# UNITED STATES PATENT AND TRADEMARK OFFICE

APPLICATION NO.	FILING DATE	FIRST NAMED INVENTOR	ATTORNEY DOCKET NO.	CONFIRMATION NO.
10/729,235	12/05/2003	Roger Thomas	P-US-PR 1112	9207

## Office Action Summary

**DETAILED ACTION*****Continued Examination Under 37 CFR 1.114***

FIG. 1

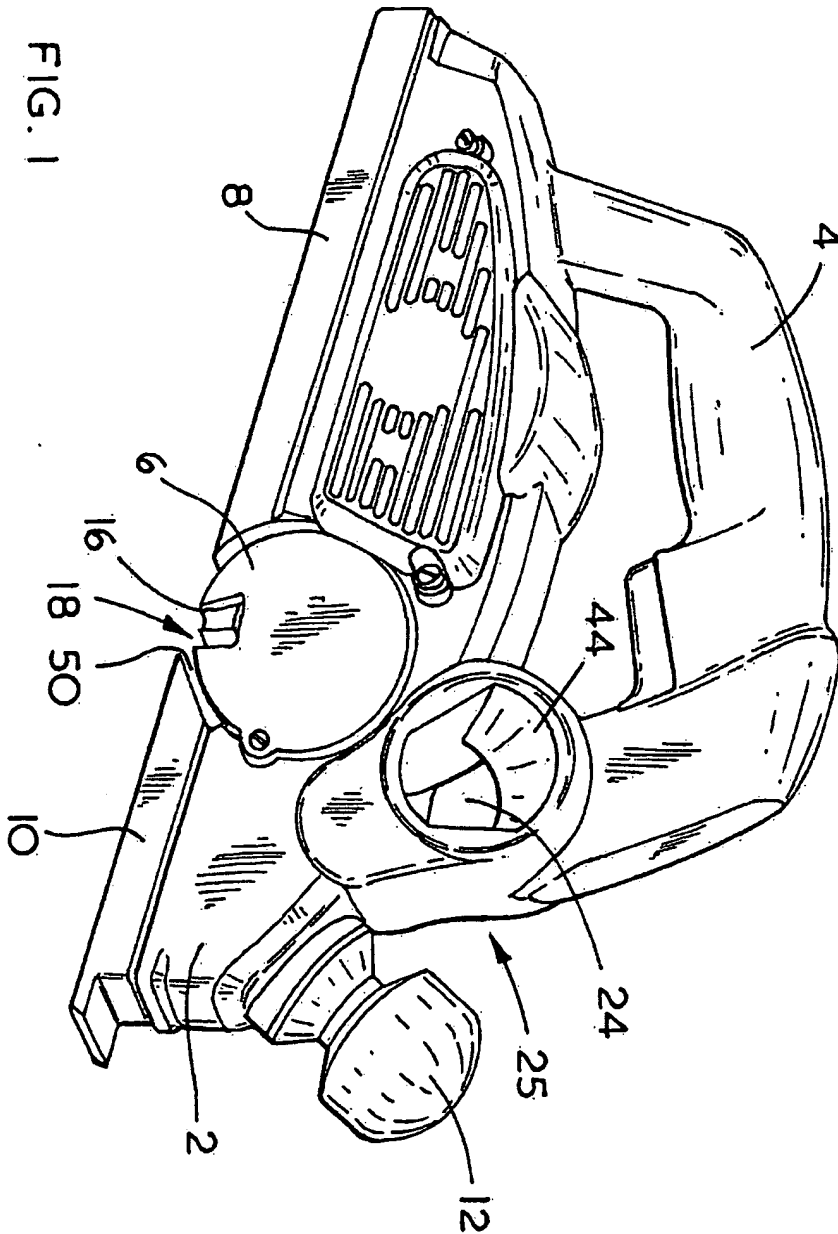
Claims 1, 3, 5-10, 12 and 13 are rejected under 35 U.S.C. 103(a) as being unpatentable over Maier et al (DE3542263). Maier discloses a planer comprising; a shoe (12) the shoe defining an aperture (fig. 1); a body mounted on the shoe (fig. 1) the body defining an exhaust aperture (17) and including a wall, the wall defining a recess (fig. 1), a cutting drum (11) within the recess, the drum having a periphery and a portion of the periphery of the cutting drum projects through the aperture in the shoe (fig. 1); a motor, a cutting blade, an airflow generator, a conduit (23) defined within the body for directing airflow, the conduit in communication with

the exhaust aperture and connected to the recess for entraining and removing debris; a deflector (22), a flap (21) movable where the flap closes the exhaust aperture and to a second position where the flap does not close the exhaust aperture. Maier does not disclose the deflector to be removable. It would have been obvious at the time of the invention to one having ordinary skill in the art to construct Maier such that the deflector (22) is removable because forming in separable, i.e., removable parts what was formerly constructed as an integral structure requires only routine skill in the art. *Nerwin v. Erlicnman*, 168 USPQ 177, 179.

With regard to claim 3, Maier discloses wherein a wall in the body also defines an expulsion aperture and the conduit (23) is connected to the recess (fig. 1) by the expulsion aperture (16) and the cutting action of the blade causes debris created by the cutting to be ejected from the recess through the expulsion aperture (16) and into the conduit substantially along a first direction and the airflow in the conduit is directed within the body to a point below the expulsion aperture and then is directed by the conduit to be blown across the expulsion aperture along a second direction the first direction of the debris and the second direction of the airflow intersect at an acute angle. Examiner notes the airflow traveling along a line, the debris/chips traveling along a second different line the two lines intersect so as to allow the airflow to blow/direct the debris out of the exhaust aperture. Because the two lines of direction intersect and supplemental angles are formed, one angle being acute and one being obtuse, thus Maier obviously discloses intersecting of the travel directions at an acute angle.

With regard to claims 5 and 6, Maier discloses wherein the conduit (23) directs the airflow over the deflector (22) prior to directing the airflow to the point below the expulsion aperture. Examiner notes the ability of the deflector to rotate facilitates direction airflow over the deflector prior to directing the airflow below the expulsion aperture.

As to a first and second position (clms. 7, 8), Examiner notes the flap (21) to be rotatable, thus positions are determined by the operator, i.e. the operator may stop rotation of the flap at any position within the range of rotation. Therefore having at least a first and second position.

With regard to claims 9 and 12, Maier discloses wherein the flap (21) extends from a pivot axis to side of the body (10).

With regard to claim 13, it is obvious in Maier that the flap be biased to a first or second position so as to adequately close either a first opening of the exhaust aperture (17) or a second opening so as to allow the debris/chips to be ejected from either side of the body via the exhaust openings (17).
